## **DELEGATED DECISIONS BY CABINET MEMBER FOR TRANSPORT MANAGEMENT**

**04 SEPTEMBER 2025**

### **FARINGDON: COXWELL ROAD – PROPOSED HIGHWAY IMPROVEMENTS**

**Report by Director of Environment and Highways**

S278 TRAFFIC REGULATION ORDER PLAN

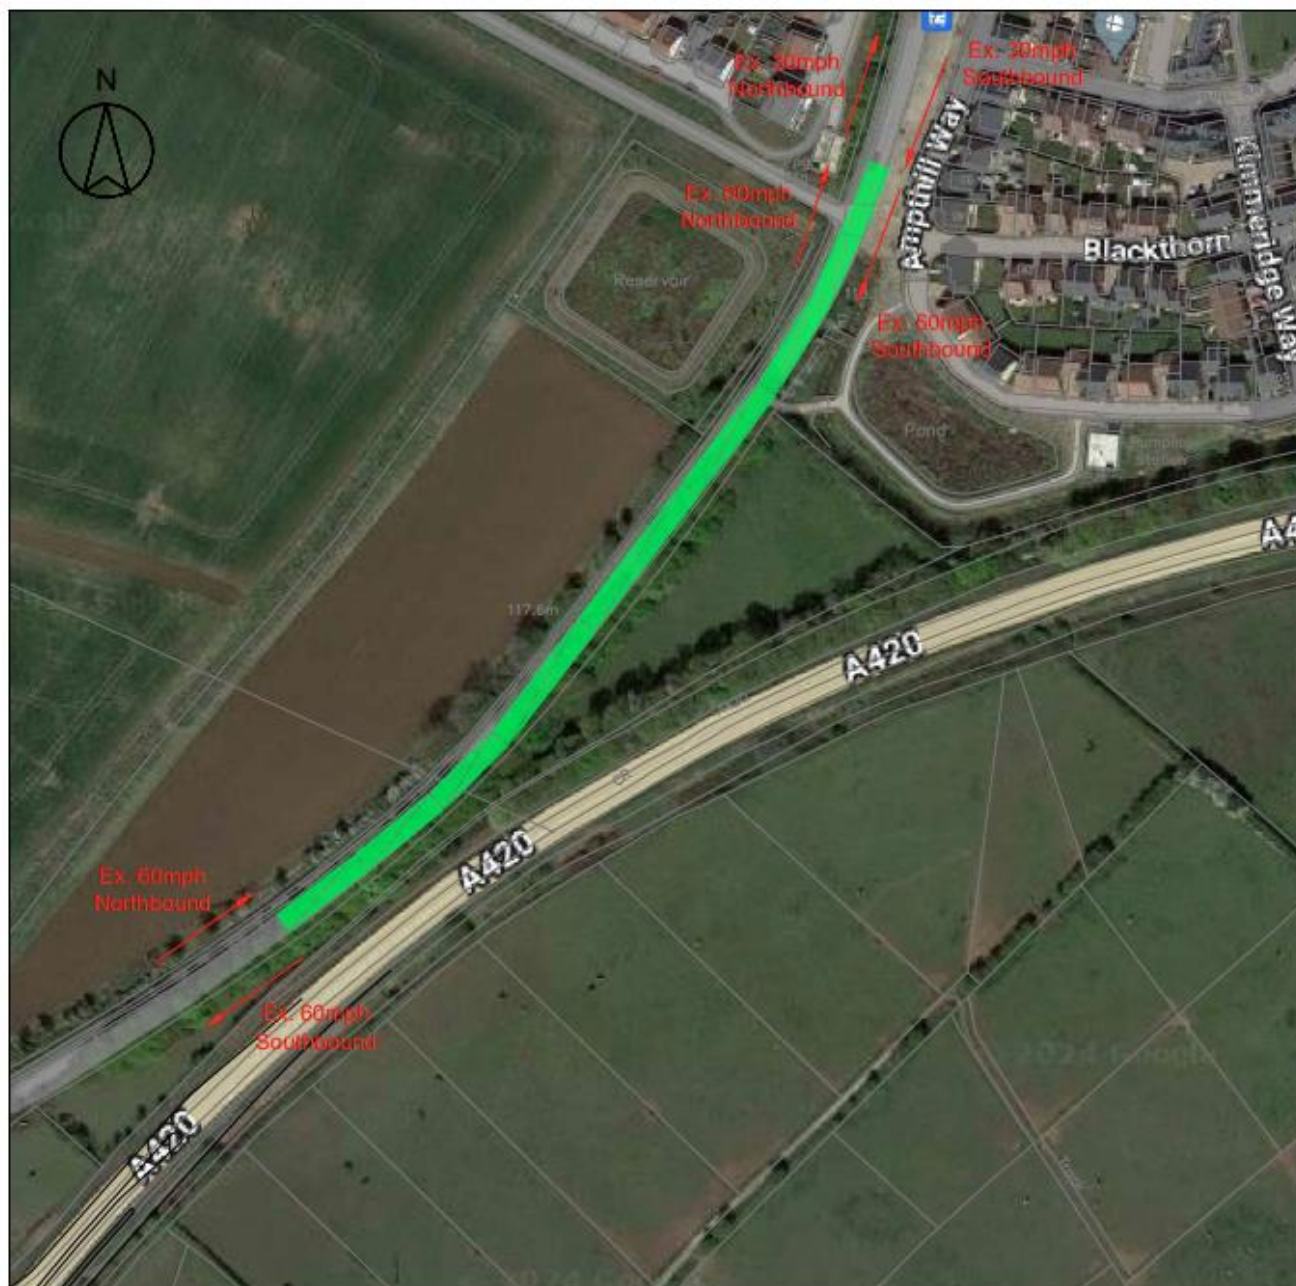
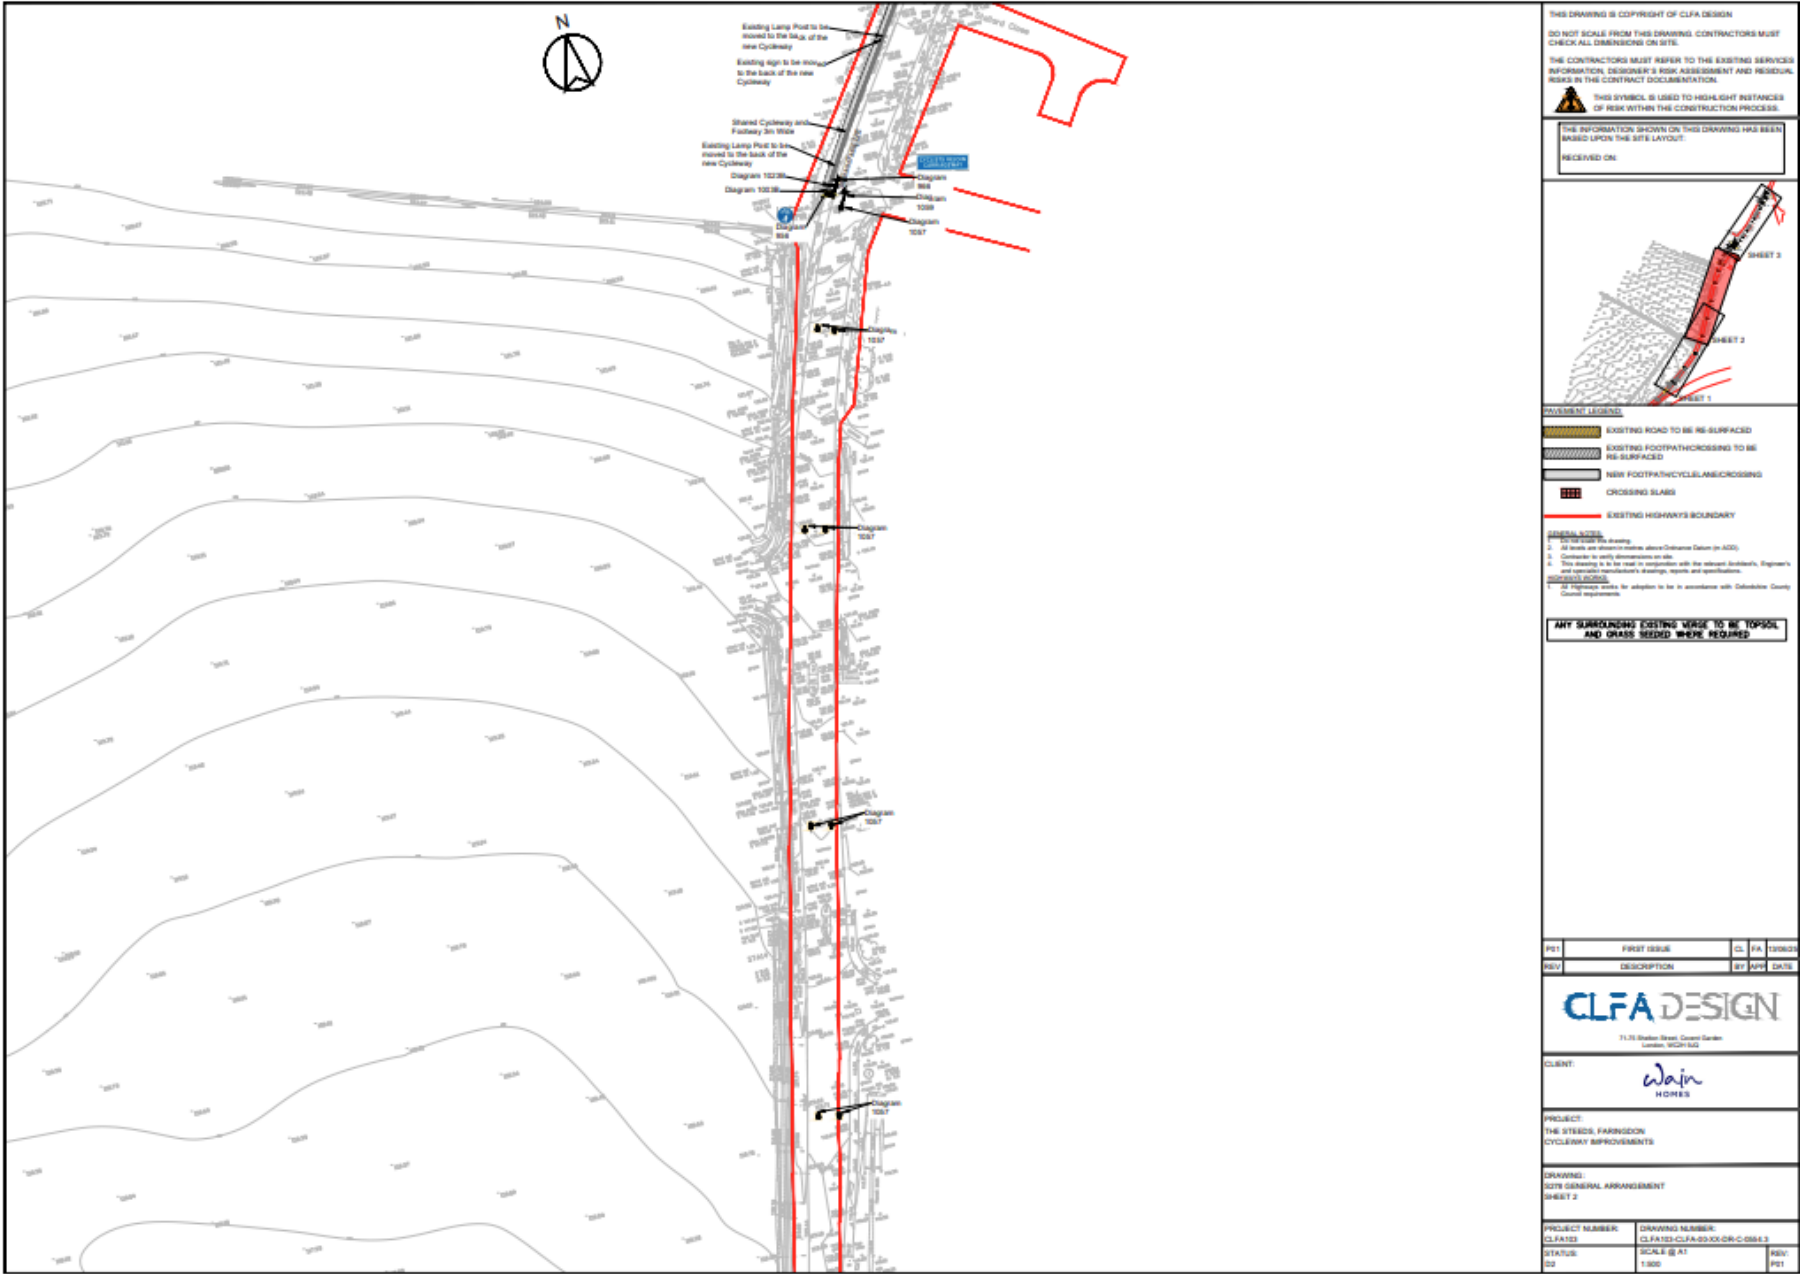
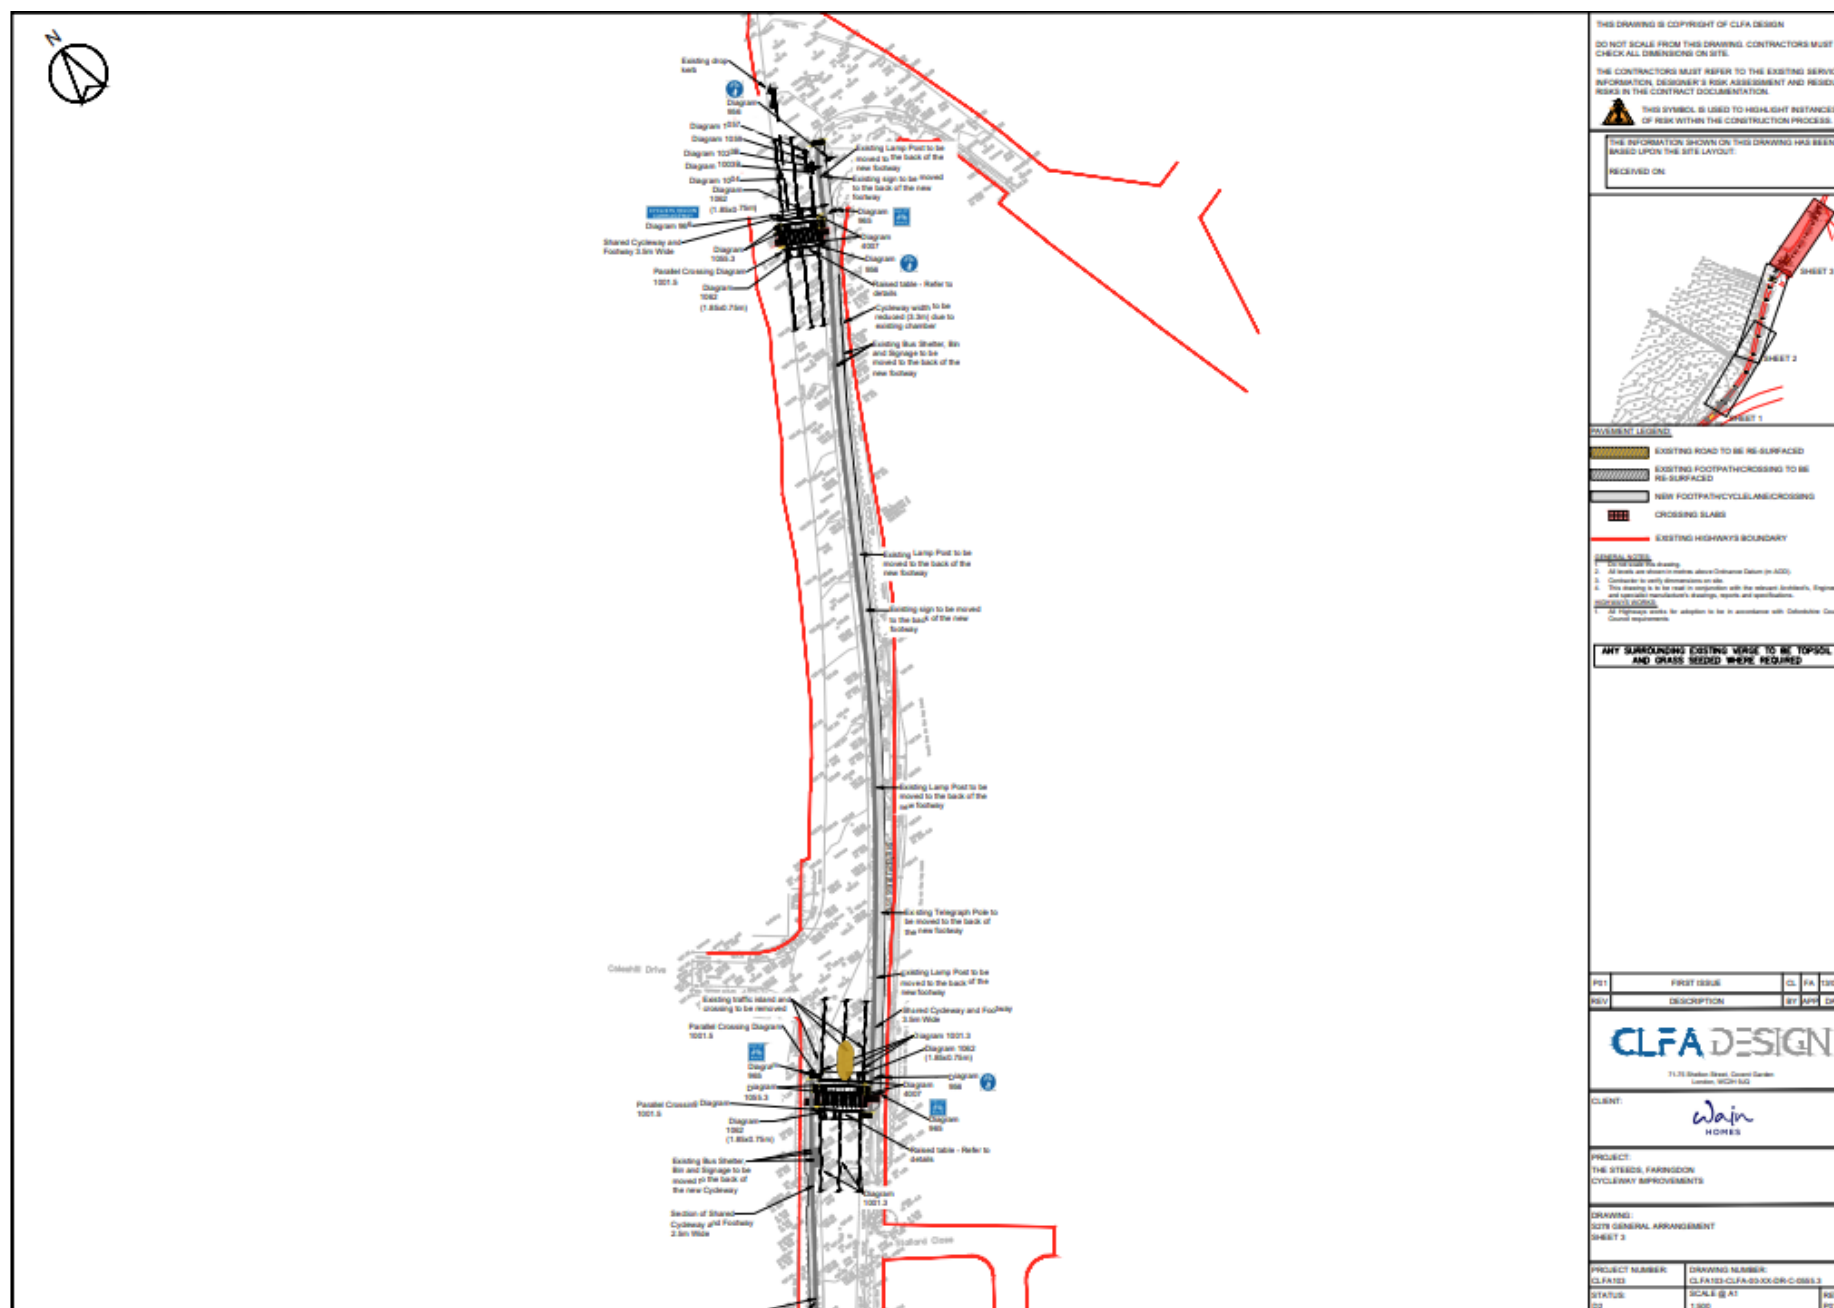
16. The speed limit proposals were well supported with 81% of on-line respondents in support. Comments were received that the proposed 30mph speed limit should be extended further and the 20mph speed limit should be extended to Coleshill Drive.

30. One resident suggested extending the proposed 30mph speed limit towards the small roundabout. However, this is outside the remit of the current works. Extending the 30mph speed limit without self-enforcement could lead to reduced compliance as drivers approach the new junction. The current location is considered the most appropriate to ensure compliance with the speed limit when entering the new junction arrangement.

Coxwell Road 30mph TRO: From a point near the existing speed limit gateway approximately 20m north of Blackthorn Row to a point 84m south of the proposed site access.
